| Reference: | 20/06052/DISC |
| Address: | 56 Woodmere Avenue Croydon CR0 7PD |
| Proposal: | Details pursuant to the discharge of conditions 7 (landscaping), 9 (SuDS) , 10 (play-space), 13 (visibility splays) and 15 (emissions) from planning permission 19/01352/FUL for 'Demolition of a single-family dwelling and erection of a 3- storey block containing 2 x 3- bedroom and 7 x 2-bedroom apartments with associated access, 9 parking spaces, cycle storage and refuse store'. |

Although this application (**Ref: 20/06052/DISC**) is NOT identified for public consultation, we would like to place on record our concerns relating to the applicant's request for approval of **Condition 9 (SuDS)** with reference to our objections and the Case officer's report and the **AMBIENTAL Report on Surface Water Management:**

The supplied photographs of the site progress were taken on 8th December from 54 Woodmere Avenue.

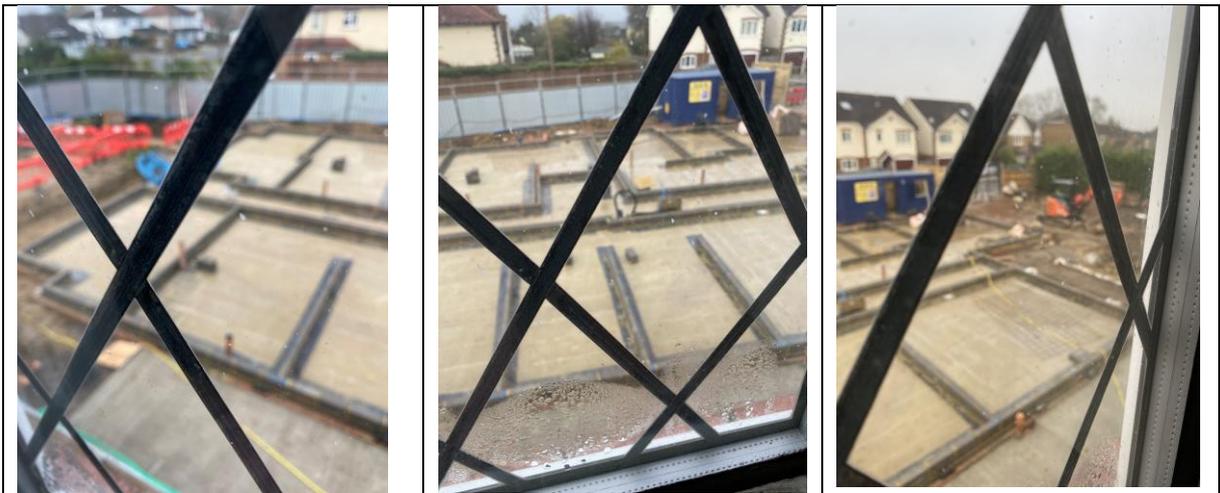
The current development progress as illustrated below shows Foundations and Footings are virtually completed and the floor levels probably established ready for "above ground level" works to proceed on approval of relevant conditions.

The progress of the build may have already determined the finished floor and threshold levels which may prevent the AMBIENTAL proposals for mitigating surface water flooding being implemented.

We would advise that **Building Control** makes an urgent site visit to establish whether the build can accommodate the AMBIENTAL report recommendations.

See circled excavated ground level of the approved amended plans illustrated above.
